Cluster Development

South Windsor, Connecticut

Review Date: JULY 15, 1986

ENVIRONMENTAL REVIEW TEAM REPORT
ON
THE FIANO CLUSTER DEVELOPMENT
SOUTH WINDSOR, CONNECTICUT

PROPOSED
DA-15 MULTI-FAMILY RESIDENTIAL SUBDIVISION
PRELIMINARY SITE PLAN 1"=100'
14- 2 FAMILY HOMES.
73± TOTAL HOMES 59 SINGLE FAMILY HOMES

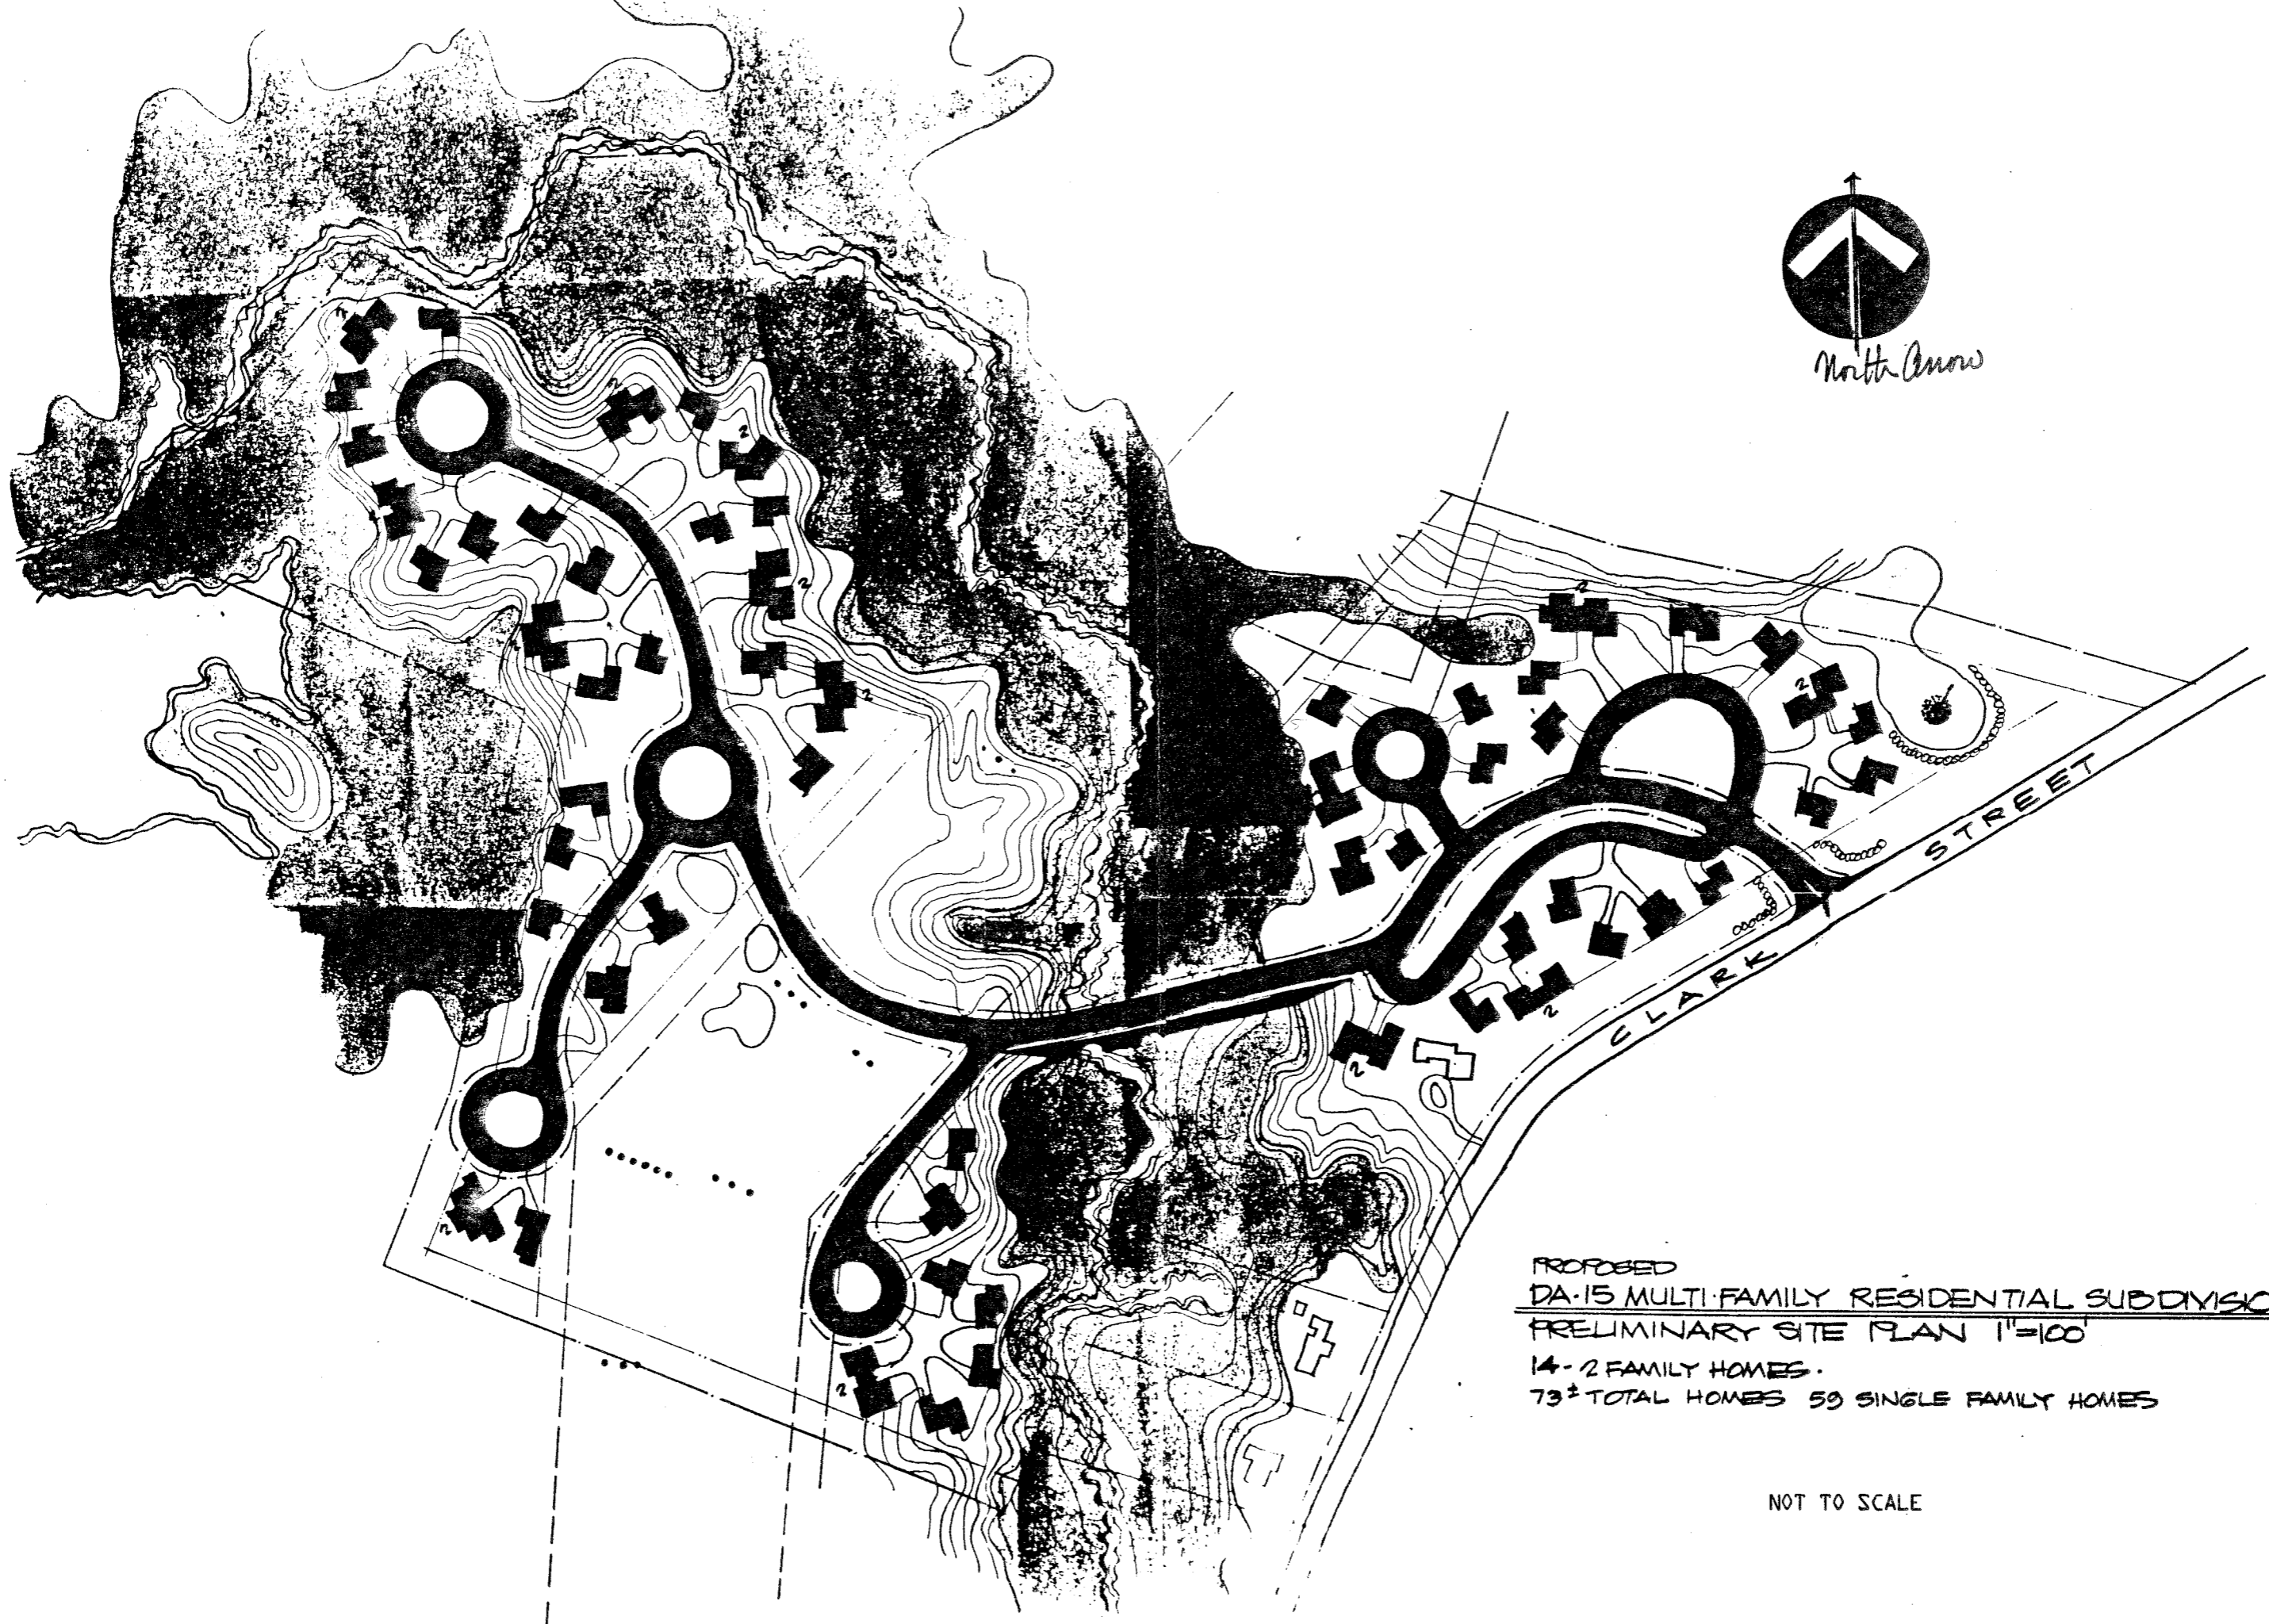
4.} Draft Plans received for this review were generally lacking in enough detail to determine on and off-site impacts of the proposed development. More soil and topographical information will be needed. Once information and design are developed a second review would be in order.

5.} Location of proposed stormwater detention basins were shown at the review meeting but not indicated on plans for the field review. It is strongly suggested that all stormwater detention basins be constructed out of the 100 year floodplain and wetlands.

9.} If proposed grades for the project will follow those illustrated in the review plan, significant removal of existing vegetation will be required. Careful site planning and layout will be necessary in order to save existing trees.

Based on the site plan distributed to Team members on the review day, about 300 feet of Plum Gulley Brook and its accompanying floodplain will be crossed by an interior road.
